California Energy Commission
Building Energy Efficiency Standard Rulemaking - Dockets Unit
1516 Ninth Street, MS 4
Sacramento, CA 95814-5512
docket@energy.ca.gov

Re: Docket # 15-BSTD-01**POSSIBLE UNSAFE CONDITIONS CREATED BY CODE LANGUAGE IN THE BUILDING
ENERGY EFFICIENCY STANDARDS SECTION 130.1 (c) 6. And 130.1 (c) 7.*****INTRODUCTION:***

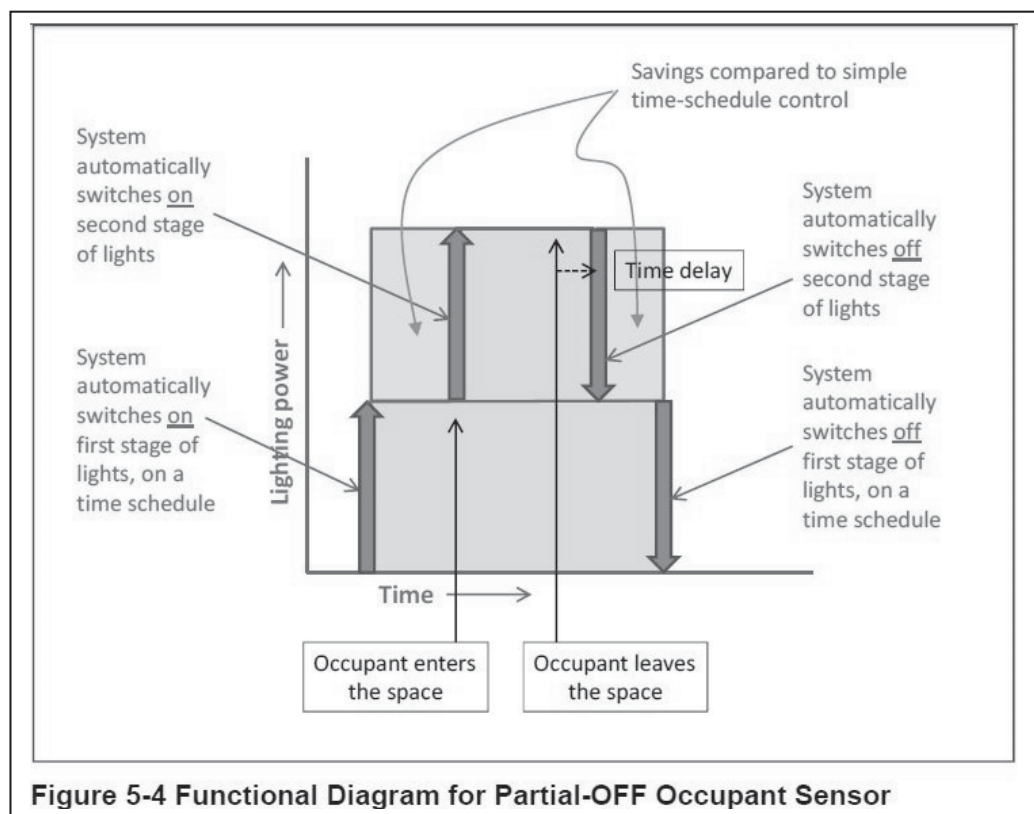
A stairwell, (not serving guestrooms), is controlled with an automatic time switch and a Partial OFF occupancy sensing device. During “occupied hours” the automatic time switch keeps some lighting on in the stairwell. This is the Partial OFF system described in 130.1 (c) 6. However, after “occupied hours” the automatic time switch shuts off the lighting it is controlling. If the lighting controls in the stairwell are arranged such that the automatic time switch “disables” the occupancy sensing device, upon occupancy, the stairwell will remain dark. This will force the entrant to seek out the automatic time switch override – hence causing an unsafe condition.

In essence, a Partial OFF occupant sensing system stipulated by Section 130.1 (c) 6. Should revert to being a Partial ON occupant sensing system during periods “... when the space is typically unoccupied ...”.

This is NOT shown in the 2013 Nonresidential Compliance Manual illustration of Partial OFF occupant sensing operation. Only operation during “occupied hours” is detailed, behavior of this system “... when the space is typically unoccupied ...” is not shown:

It is recommended by the author that some language be inserted in Section 130.1 (c) 6. To dictate that the Partial OFF requirement revert to a Partial ON requirement in the area(s) of interest “... when the space is typically unoccupied ...”. The occupant sensing control should remain capable of energizing some controlled lighting in the specified area(s) “24 hours per day/365 days per year”.
